Re: Comprehensive Cardiovascular Consultants  
NRC License 24-32459-01  
Control No. 316317

**Comprehensive Cardiovascular Consultants, Inc.**  
**Decommissioning Survey of site: 3844 S. Lindbergh Blvd, Suite 250, Sunset Hill, MO**  
**63127**

PARTIAL PLAN - NUCLEAR CAMERA

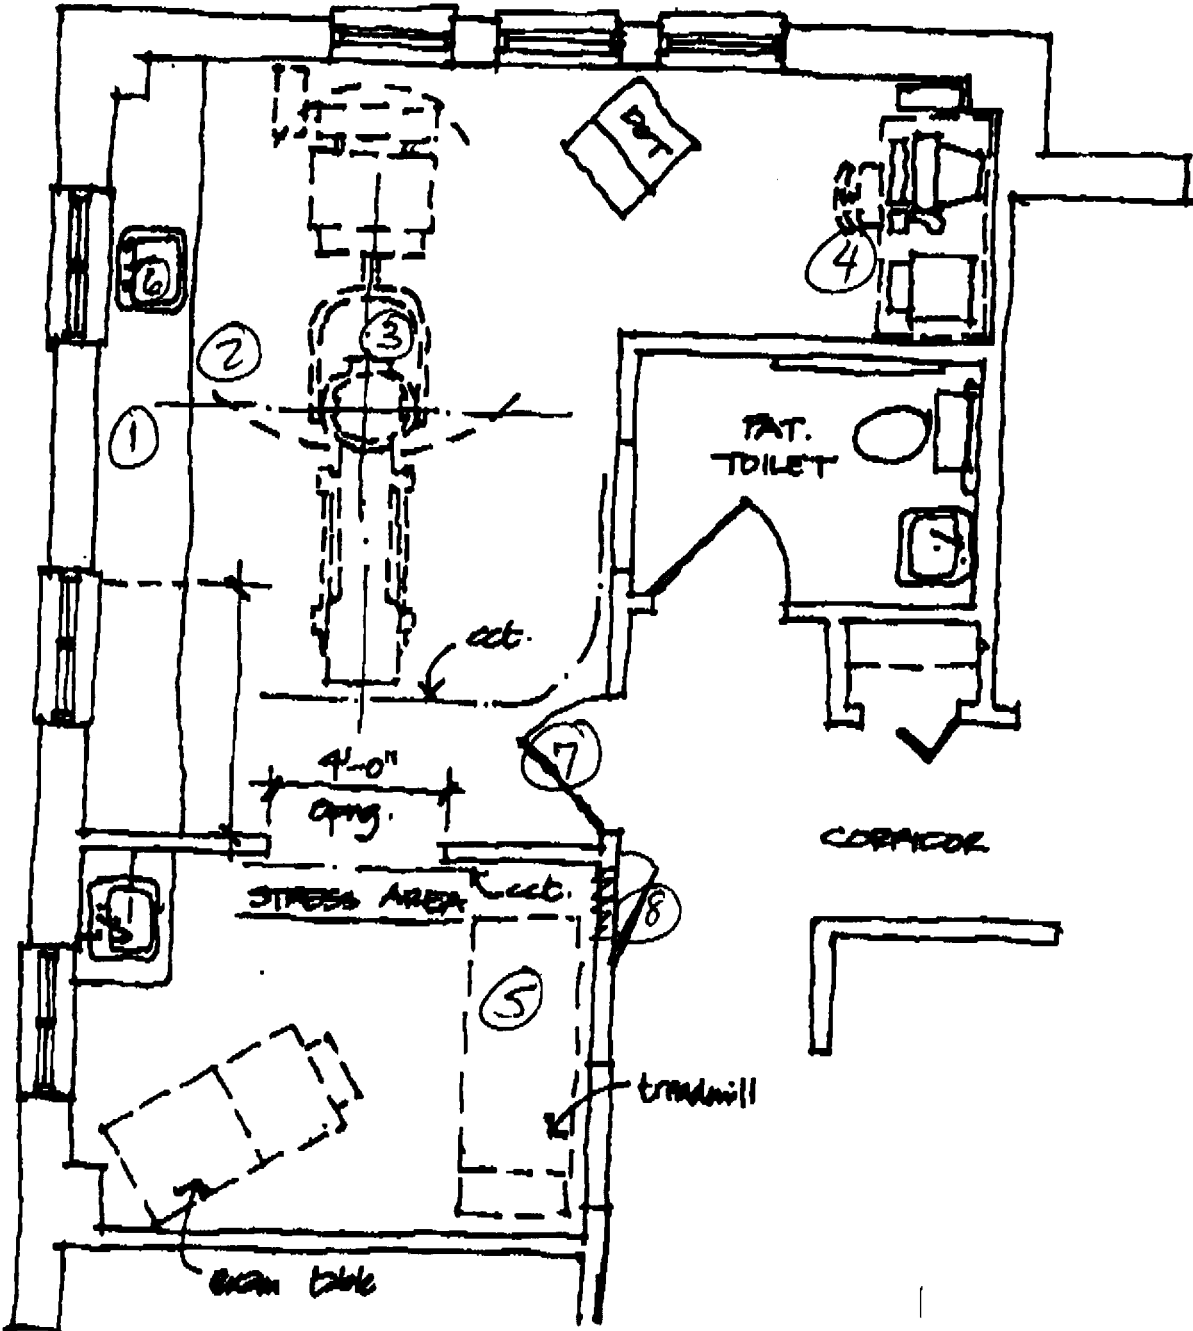
3. Please submit a sketch of the "old" facility located at 3844 South Lindbergh, Blvd., Suite 250, St. Louis, Missouri, with the G-M survey and wipe test results keyed to specific locations on the sketch.

1. The only "unsealed" sources used at the site were  $^{99m}\text{Tc}$  and  $^{210}\text{Tl}$ . None of these radionuclides were present at close-out. No  $^{131}\text{I}$  in the form of NaI was present in the facility. See the inventory attached.
2. The Sealed Source Leak Test and Inventory, dated 6/6/07, (Attachment 2-a), is a copy of the leak test results that were current at the time of the close-out survey for the sealed sources used or stored at the said facility. Attachment 2-b shows additional leak test results performed Oct. 01, 2003, as the only other historical reference data.
3. Attachments 3a and 3b provide a sketch of the facility with G-M and wipe test results keyed to the specific locations on the sketch.
4. The instrument used to perform the wipe tests is the Atomlab 450.

1 Hot Lab Counter	0.02 mR/hr
2 Hot Lab Floor	0.02 mR/hr
3 Camera Area	0.02 mR/hr
4 Computer Area	0.02 mR/hr
5 Treadmill Area	0.02 mR/hr
6 Hot Lab Sink	0.02 mR/hr
7 Imaging Room Door	0.02 mR/hr
8 Stress Lab Door	0.02 mR/hr
